AMENDMENTS TO THE DRAWINGS:

REMARKS

Appendix A

(Marked Up Sheets – Figures 3, 15 & 16)

Fig.3.

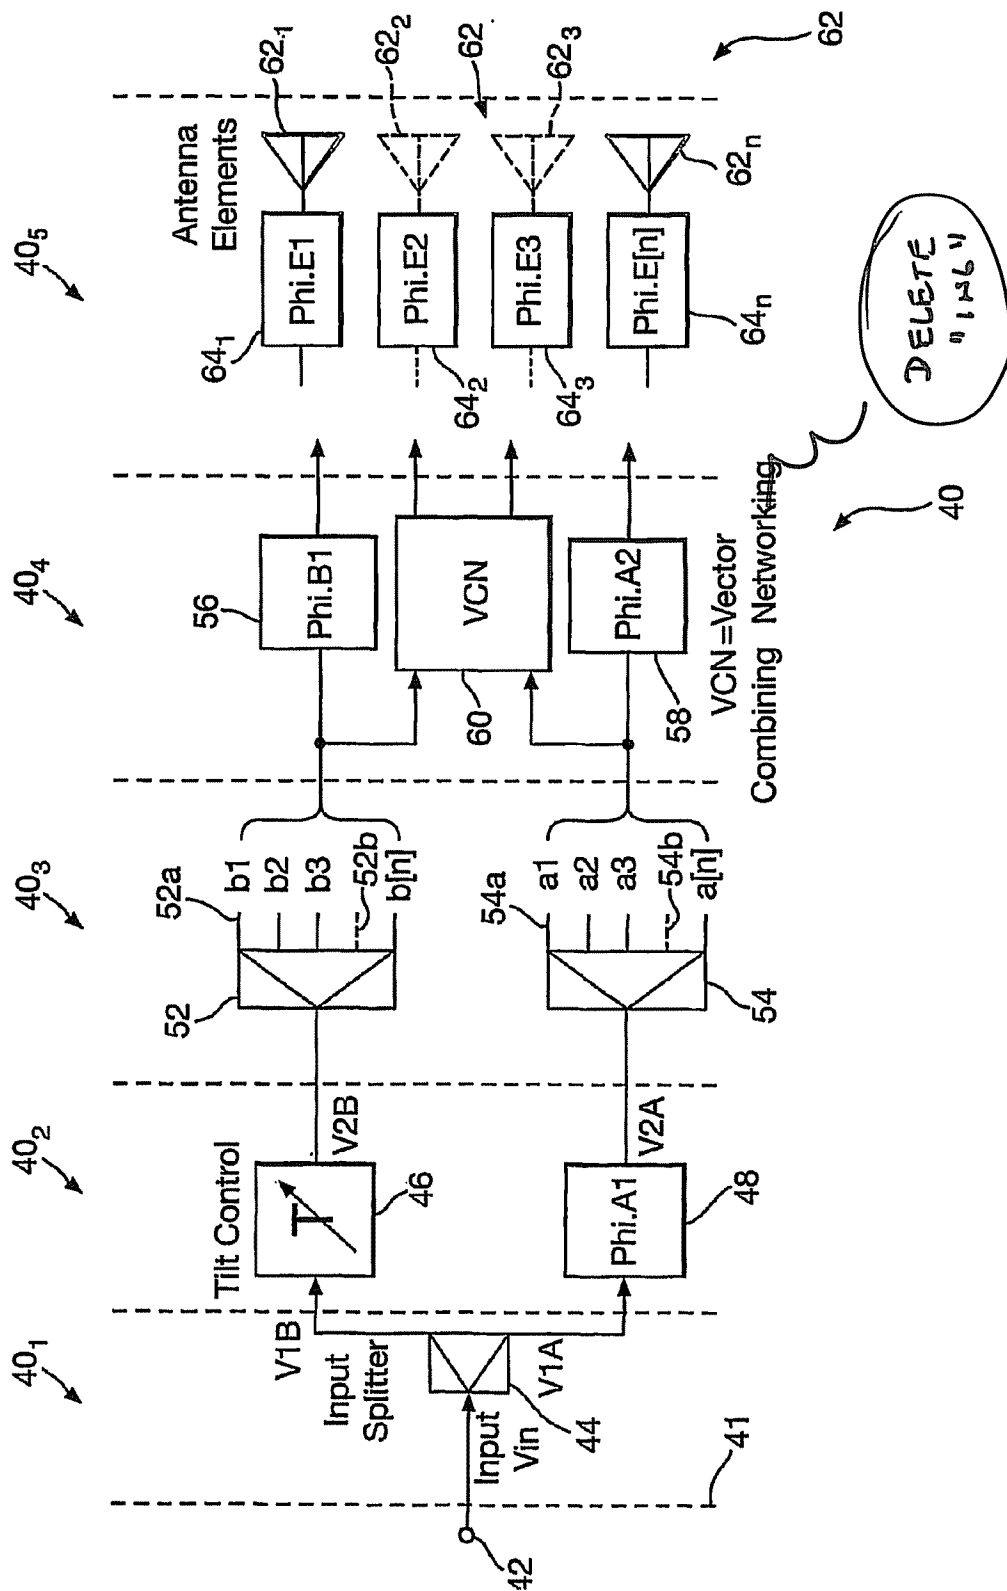
The attached drawing sheets include amended and marked-up versions of Figures 3, 15 and 16. Figure 3 is amended to correct an error in the spelling of the word “Network”. Figures 15 and 16 are amended to include a numerical designation for the entire structure shown in each Figure.

Fig. 16.

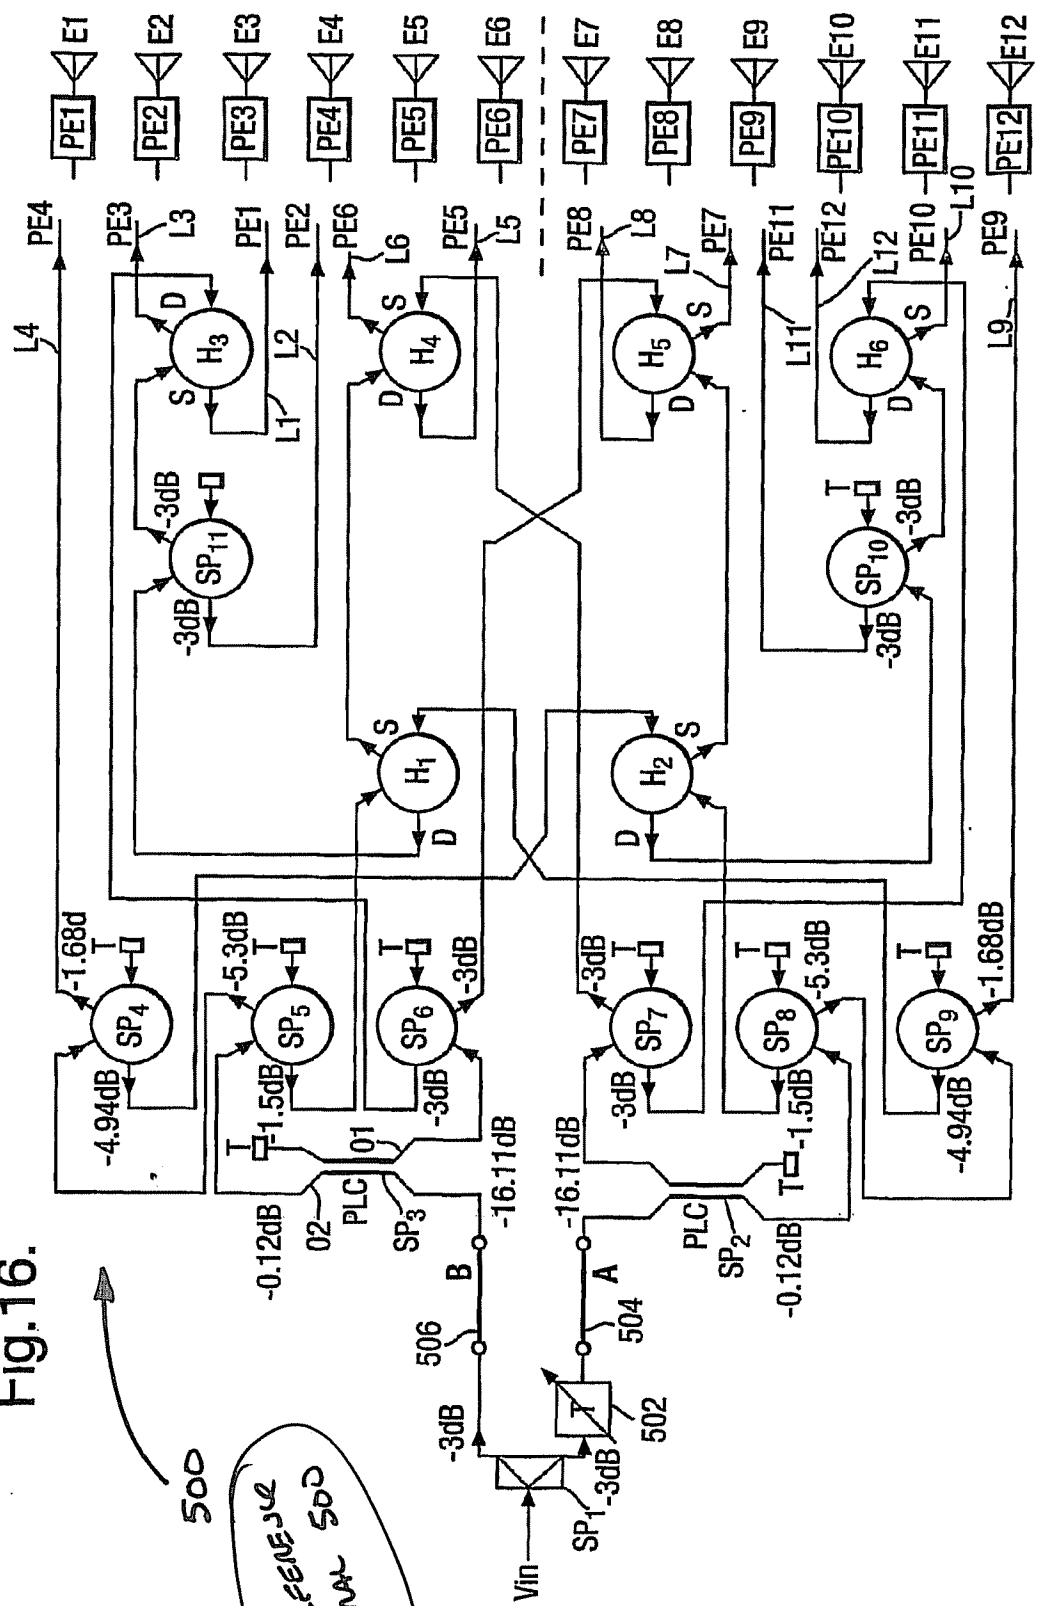
500
ADD REFERENCE
NUMERAL 500
